# Preliminary Information

## PIT5666A Squeak/Creak/Squawk/Itch Type Noise Heard From The I/P or Center Console Area

### Models

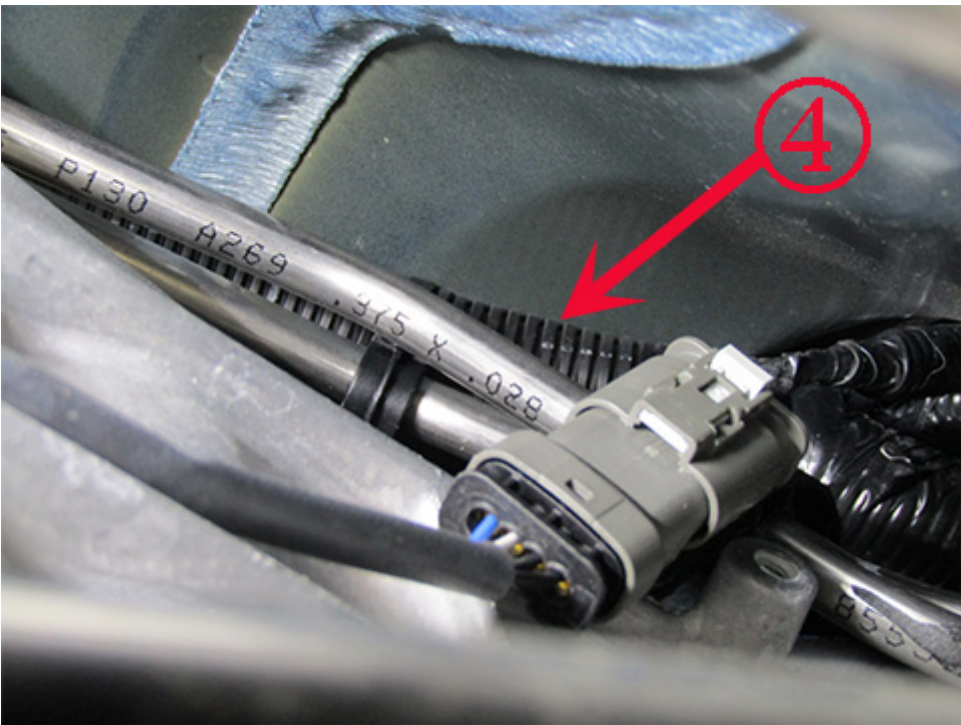
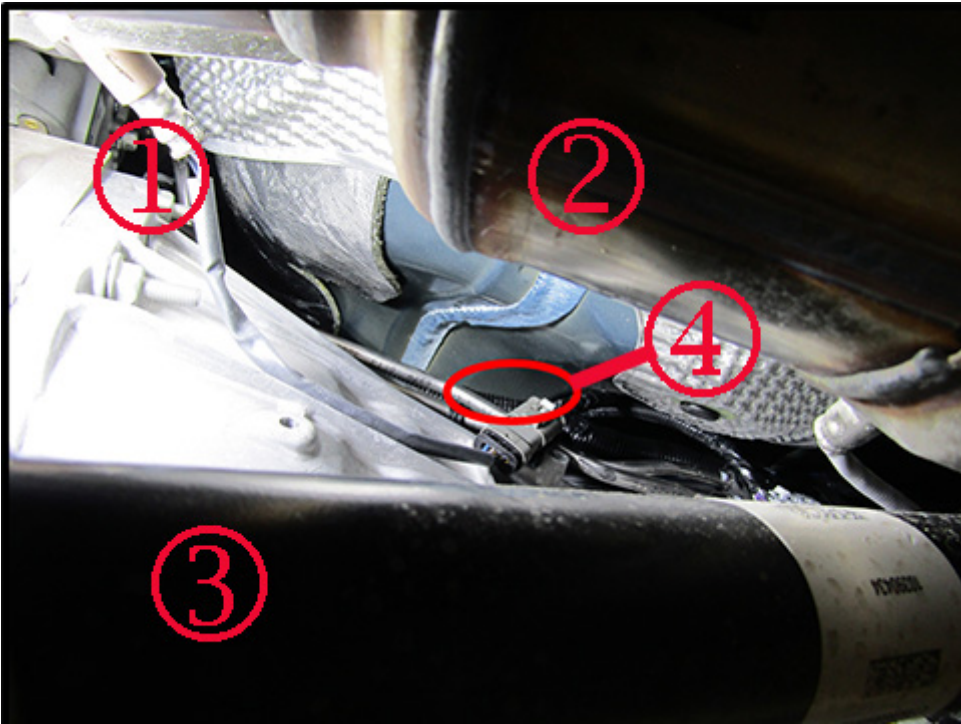
Involved Region or Country	North America
Condition	<p>Some customers may comment of a squeak, creak, itch, or rubber type noise heard from the IP dash or center console area. The noise may be duplicated by the following:</p> <ul style="list-style-type: none"><li>- Driving over bumps (noise may go away if coasting or if transmission is shifted into "N")</li><li>- During acceleration</li><li>- Brake torqueing in drive (noise may not occur when brake torqueing in reverse)</li></ul>
Cause	<p>This noise could be caused by the engine harness rubbing on the floor pan above the transmission (item numbers 4 and 5), as shown below. The photos below were taken from under the vehicle looking up along the driver's side of the transmission bell housing.</p> <p>Callout 1 - Bank 1 Sensor 1 O2 sensor Callout 2 - Bank 1 Catalytic Converter Callout 3 - Front Driveshaft (on 4WD vehicles) Callout 4 - Engine Harness rubbing on floor pan Callout 5 - Engine Harness pushed aside to show the contact on the floor pan</p>

Reposition and secure the engine harness down beside the fuel/evap lines so it no longer contacts the floor pan, as shown below. The rear transmission crossmember may need to be removed so that the transmission can be slightly lowered to gain access to the area. To allow enough slack in the engine harness to reposition it down

beside the fuel/evap lines, it needs to be moved/repositioned forward in the clips at the rear of the harness above the rear of the transmission/transfer case. First, release the rear harness clips and move/reposition the harness forward in the clips, then lock the clips closed. This will create enough slack in the harness to reposition and secure the harness down beside the fuel/evap lines, as shown below.
